DSP-06001-03

Detailed Site Plan The Commons at Addison Road Metro

STAFF REPORT

SUBJECT:Detailed Site Plan DSP-06001-03Type 2 Tree Conservation Plan TCP2-013-2019The Commons at Addison Road Metro

PERSPECTIVE ILLUSTRATION

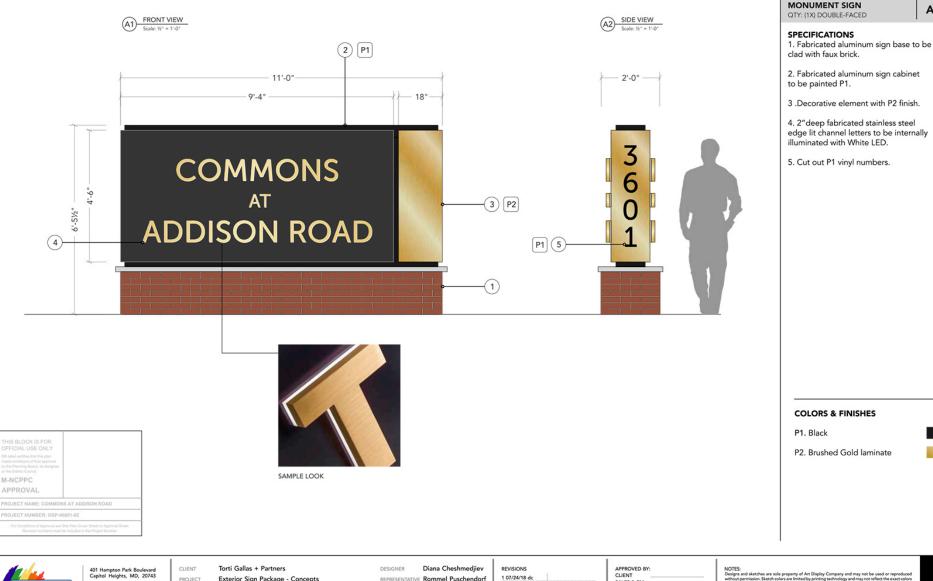
The building is oriented toward MD 214 and is located approximately 55 feet from the public right-of-way. Between the building and the street, the DSP proposes to enhance the streetscape by including an 8-foot pedestrian sidewalk along MD 214 and a generous amount of landscaping. Three distinct plaza and courtyard areas to serve the users of the site are proposed between the building and MD 214. Each plaza includes different paving patterns and finishes to accent the spaces and provide visual interest. The plazas include a passive recreation space with grills, landscaping, and open space for residents of the building on the western end of the frontage; a central residential entrance plaza; and an urban plaza with seat walls, benches, tables, and a public art element adjacent to the ground-floor commercial portion of the building, near the intersection of MD 214 and Addison Road.

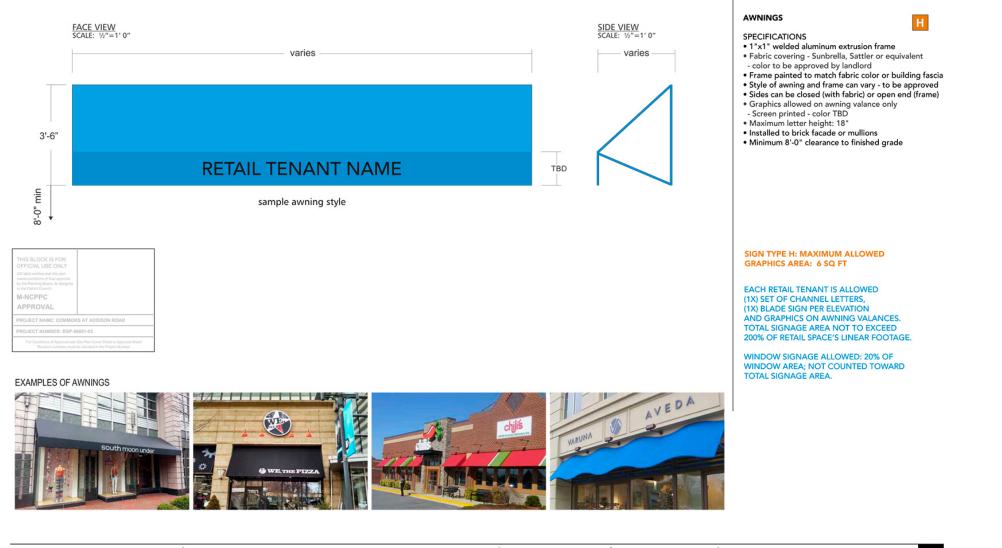
A signage schedule of the individual signs showing the square footage was included for the multifamily building, but did not include the future commercial tenants. Instead, examples of the signage proposed for the commercial tenants show blade, building-mounted, channel-letter, and canopy signs. The sign examples propose high-quality attractive sign alternatives, enhance the architectural character of the building, and create a sense of place encouraging the creation of a mixed-use development in proximity to the Addison Road Metro Station. The signage examples also propose sign standards and limit the square footage of the individual retail signs to 31.5 square feet each. The signage schedule only includes the proposed freestanding and building-mounted signage for the multifamily

building and should also include the future commercial tenant signage for clarification. This revised schedule should include a note stating that the proposed and allowed signage area is equal to, or less than, what is allowed by Section 27-613 of the Prince George's County Zoning Ordinance, as is required by the D-D-O Zone standards (page 221). In addition, it is noted that the signage schedule provided with the DSP includes wayfinding signage, such as parking and directional signage. This type of signage does not count toward the total amount of signage allowed and should be removed from the schedule.

Therefore, conditions requiring the applicant to revise the signage schedule have been included in the Recommendation section of this report.
